CITY OF PORTLAND, MAINE

February 3rd, 2014

Project Name: "118 on Munjoy Hill" Condominium
12 unit residential, and 2 unit commercial, condominium
Project ID: #2013-255
Project Address: 118 Congress Street
CBL: 16-D-2
Applicant: Ed Theriault, EMT, LLC (118 Condominiums, LLC)
Planner: Jean Fraser

On January 28th, 2014 the Portland Planning Board considered and approved a Level III Final Site Plan and Subdivision proposal for the construction of a 4-story 14 unit condominium building at 118 Congress Street, comprising 2 commercial units totaling approximately 1800sq ft floor area, 18 parking spaces on the ground floor to the rear of the commercial units, and 12 residential units above.

GROUND FLOOR PLAN
 DEC 27, 2013
 As Indicated

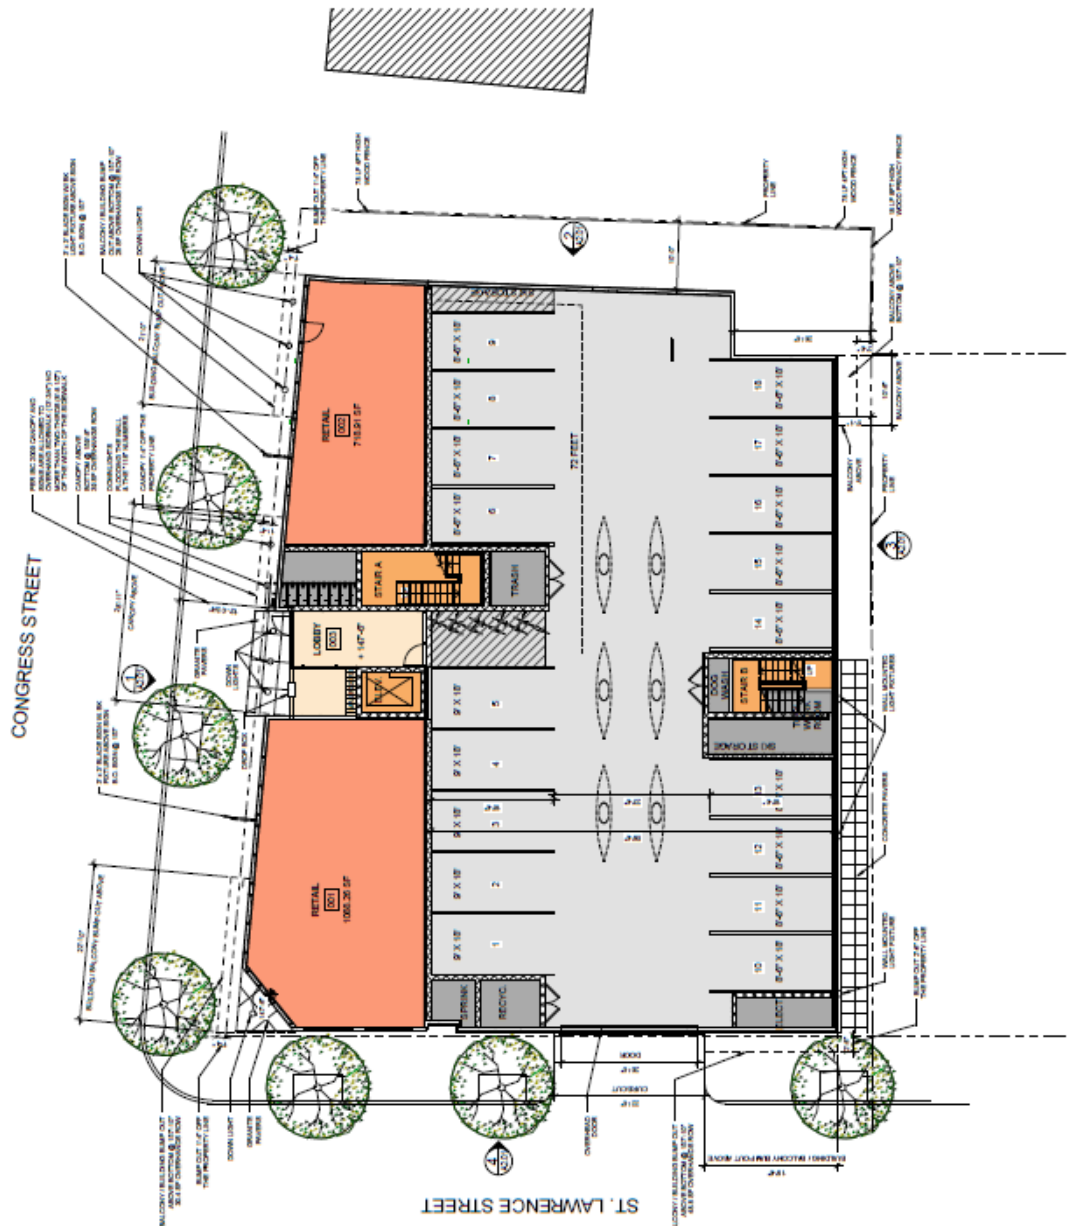
1. The Planning Board voted 7-0 to waive the Technical Design Standard Section 1.14 *Parking Lot and Parking Space Design* to allow for 13 of the indoor parking spaces to measure 18 feet by 8'6".
2. The Planning Board voted 7-0 to waive the Technical Design Standard Section 1.14 *Parking Lot and Parking Space Design* to allow a drive aisle of less than 24 feet, as shown on Plan P12.

- * Some of the parking spaces on site do not meet City standards (reduced size - but larger than compact size spaces) and a waiver will be required. A formal waiver and supporting information shall be provided by the applicant.

Status: In addition to the request for a parking stall dimension waiver, the applicant is also requesting a waiver for a reduction in parking aisle width from 24 feet to 23 feet. I support waivers from these City standards.
